Wisconsin Department of Transportation

Proposal: #07 5804-00-74, WISC 2016 469
Fritz Road, Town of Montrose
Flynn Creek Bridge B-13-0675
Town Road
Dane County

This is Addendum No. 01, which provides for the following:

Addendum No. 01
ID 5804-00-74
Revised Sheet 5
December 6, 2016

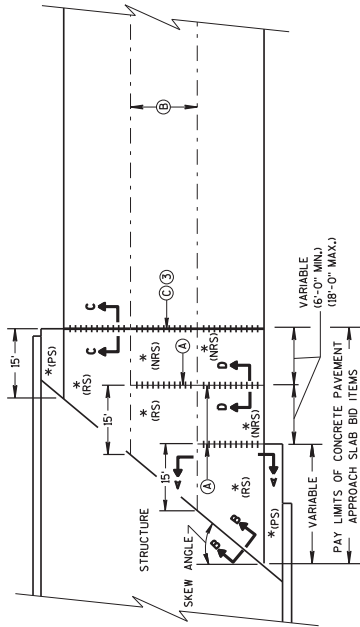
Revised Plan Sheets	
Plan Sheet	Plan Sheet Title (brief description of changes to sheet)
02	Typical Sections
05	Miscellaneous Quantities
07	Plan and Profile

Revised: 2, 5 and 7

STATION	TO	STATION	LOCATION	305.0120
				1 1/4 INCH TON
1+25	-	2+75	FRITZ ROAD	145
TOTALS				145

STATION	TO	STATION	LOCATION	415.0120	415.0410
				CONCRETE PAVEMENT 12-INCH SY	CONCRETE PAVEMENT APPROACH SLAB SY
1+25	-	2+75	FRITZ ROAD	21	87
TOTALS				21	87

Addendum No. 01
 ID 5804-00-74
 Added Sheet 11A
 December 6, 2016

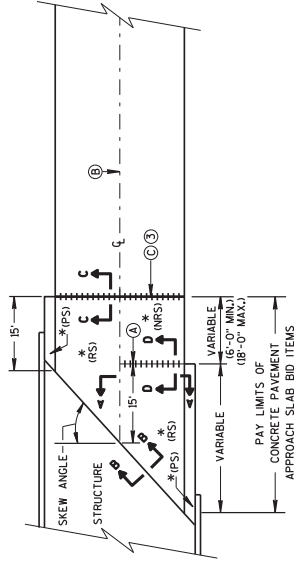
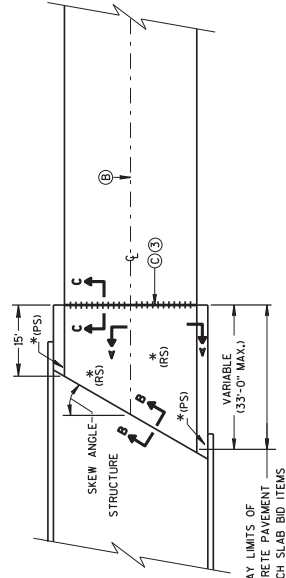
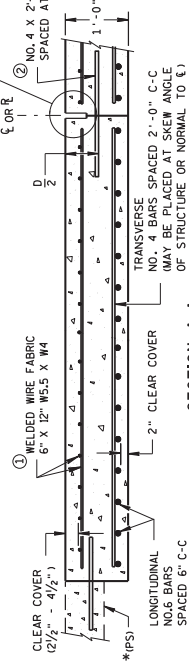
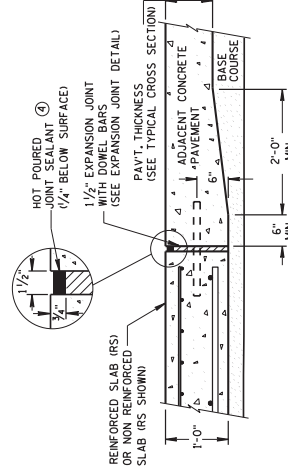
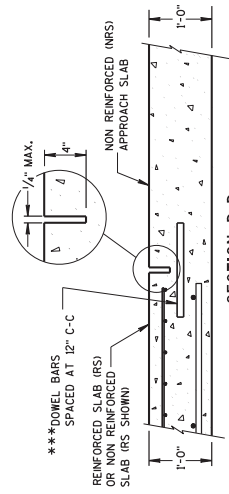
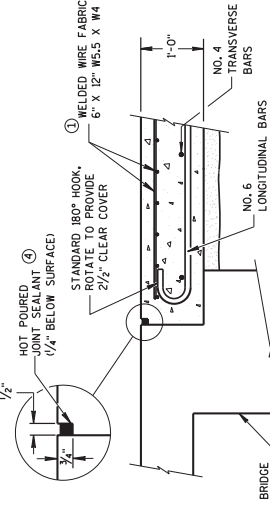
Added Plan Sheets	
Plan Sheet	Plan Sheet Title (brief description of why sheet was added)
11A	SDD - Concrete Pavement Approach Slab

Added: 11A

Added Bid Item Quantities					
Bid Item	Item Description	Unit	Old Quantity	Revised Quantity	Proposal Total
415.0120	Concrete Pavement, 12 inch	SY	0	21	21
415.0410	Concrete Pavement, Approach Slab	SY	0	87	87
